THIRD AFFIDAVIT OF MARK A. QUARLES

3. I have prepared two previous affidavits in response to the 1.) Environmental Report, Turkey Point Plant, Units 6 and 7, Revision 3 (ER) prepared by Florida Power & Light Company (FP&L) (referred to hereinafter as the "First Affidavit", January 23, 2012) and 2.) Florida Power & Light Company's Response to Joint Intervenor's Motion to Amend Contention 2.1, February 10, 2012 prepared by Florida Power & Light Company (referred to hereinafter as the "Second Affidavit", February 17, 2012) relative to the potential for wastewater injection operations to contaminate the groundwater and drinking water aquifers.

Figure 1: Map of Lidar land elevations and bathymetry showing locations of marine seismic-reflection profiles (black lines) acquired on peninsular and offshore southeastern Florida during 2007-2011. A normal fault (Figure 2) that intersects five profiles is shown as red line.

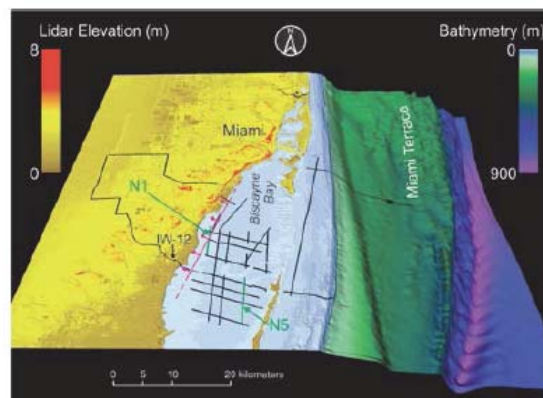
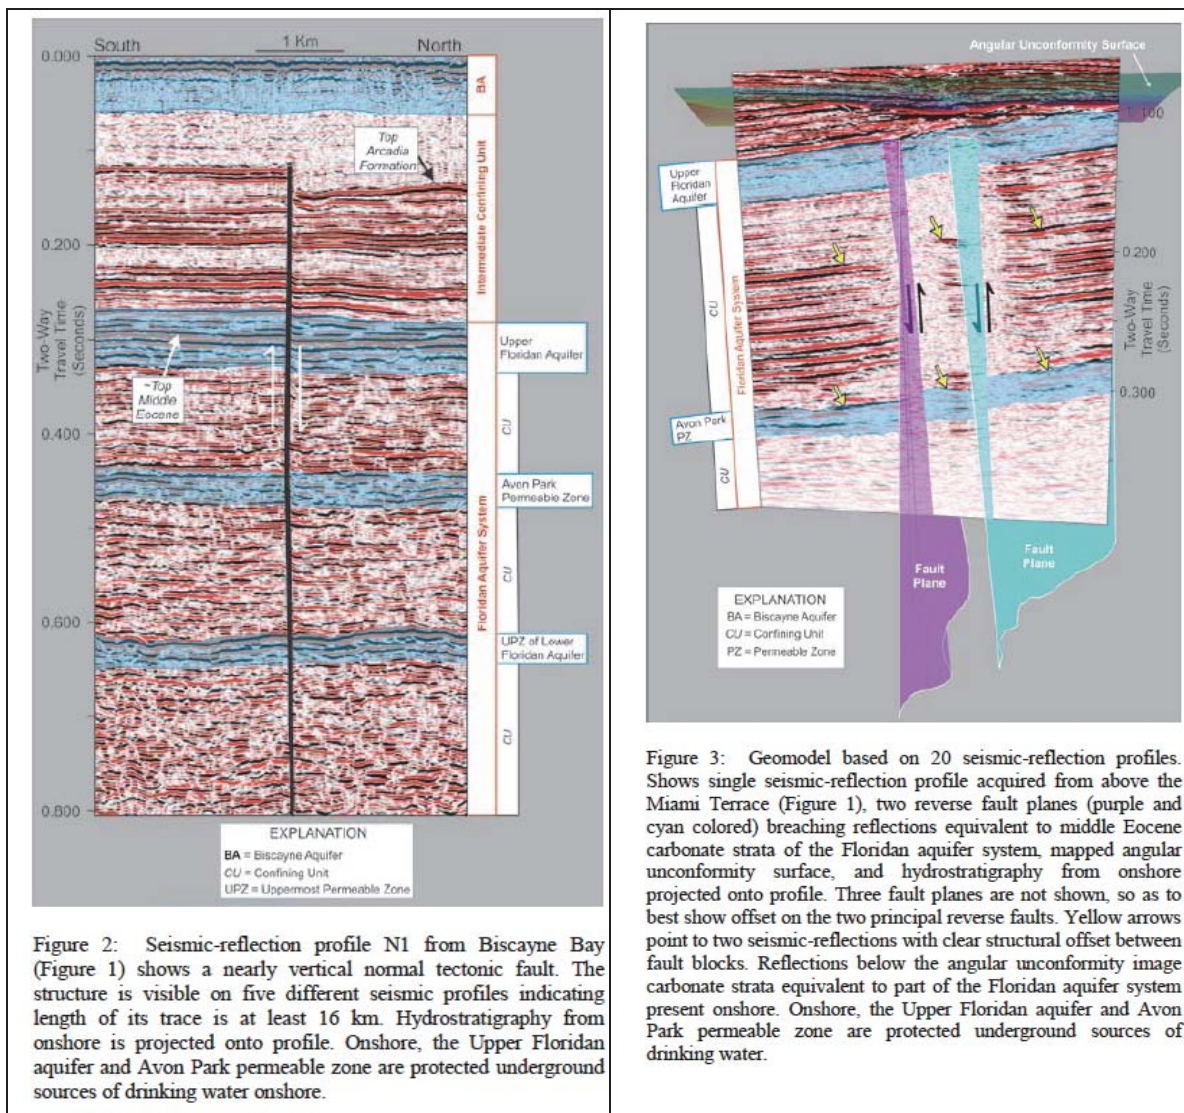
30. A more recent (2012) and a more Turkey Point area-specific report by the USGS – a report that was not relied upon by FP&L or the NRC DEIS review team – actually collected data very near the Turkey Point site. The study was completed because of an “immediate need” to supplement the 2008 Reese and Richardson study because of the practice of deep well injection of municipal wastewater and the threat to USDWs. Cunningham at 1. The purpose of that study was to evaluate geologic formations in the Biscayne Bay and its shoreline and to determine whether or not those formations are true confining layers that can protect USDWs – specifically analyzing bedrock characteristics that can “act as vertical passageways for upward fresh water migration.” Cunningham at 1 and 2. Data from 2007 through 2011 was used to provide a “new perspective” of subsurface geologic details for the Biscayne Bay adjacent to the Turkey Point site. That study collected 130 miles (210 kilometers) of near-surface, high frequency, marine seismic reflection data that were interpretable to a depth of 2,396 feet below ground surface. Cunningham at 1 and 2. A diagram of the seismic profiles from that report is as follows:

31. The Cunningham study concluded that two different bedrock structural systems – tectonic faults and karst collapse structures – both breach bedrock confining layers in the Floridan Aquifer system. Cunningham at 1. One such breach is a fault that runs along the shoreline of the Biscayne Bay (noted in red in the illustration above). The Turkey Point site is along the shoreline of Biscayne Bay. Most importantly as it relates to the proposed deep well injection at the Turkey Point site, the report concluded “both structural systems may serve as pathways for vertical groundwater flow across relatively low-permeability carbonate strata that separate zones of regionally extensive high-permeability rocks in the Floridan aquifer system.” Cunningham at 4.

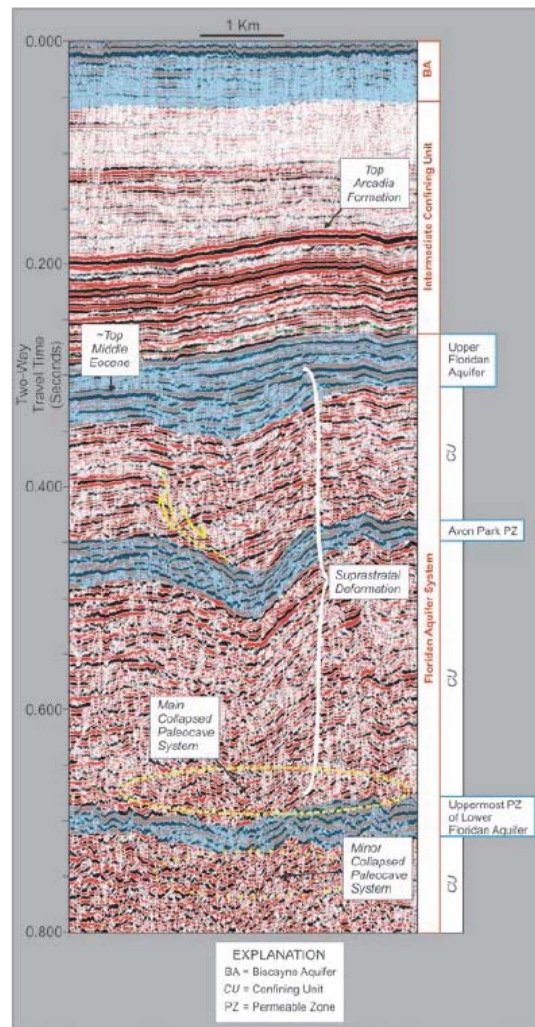
34. The Cunningham report also concluded that karst collapse structures exist in Biscayne Bay; these structures are also common beneath dry land peninsular Florida; these features also create breaches in confining layers; and such collapse features can result in upward migration of injected wastewater. Cunningham at 1, 3, and 4. Deformation in the bedrock can create substantial horizontal and vertical fractures in the bedrock – conditions that can become preferential contaminate transport pathways. An illustration of a mapped karst collapse structure from the Biscayne Bay is as follows:
